**FINDINGS AND RECOMMENDATION  
OFFICE OF PLANNING AND ZONING  
ANNE ARUNDEL COUNTY, MARYLAND**

**CASE NUMBER:** 2025-0219-V

**REQUEST**

The applicant is requesting a variance to allow a dwelling with less setbacks and buffer than required on property located at 1031 Landon Lane in Arnold.

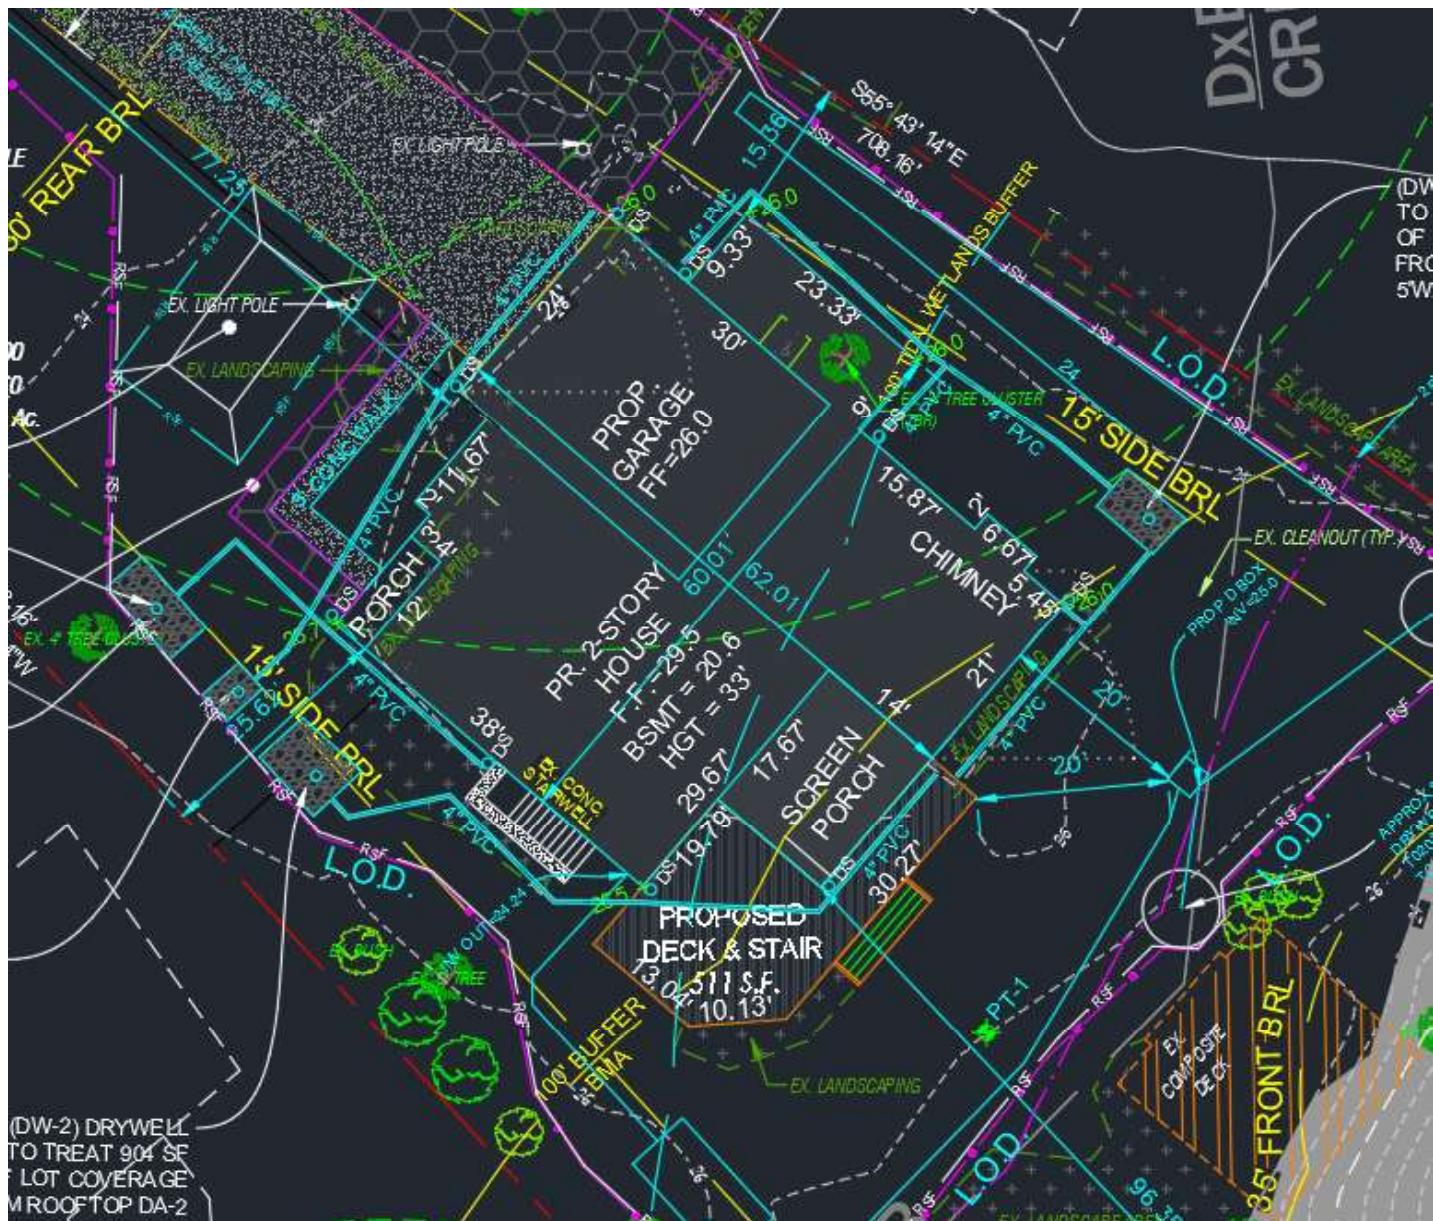
I'm working on this report and I'm at the description of the proposed house. Can you provide a rough overall dimension of the house... I'm looking to describe this as 'Irregularly shaped \_\_\_ by \_\_\_ with a garage \_\_\_ by \_\_\_ a waterfront deck and screened porch. I would add it up myself but all the measurements that I'd need are not shown on the site plan. Shown below I need the missing yellow measurement and the missing pink measurements.

I added dimensions see below.

Garage is 24x30

The house generally is 60' wide by 62' deep, I put dimension lines on you can see.

The deck and the house inside the buffer are the same as existing.
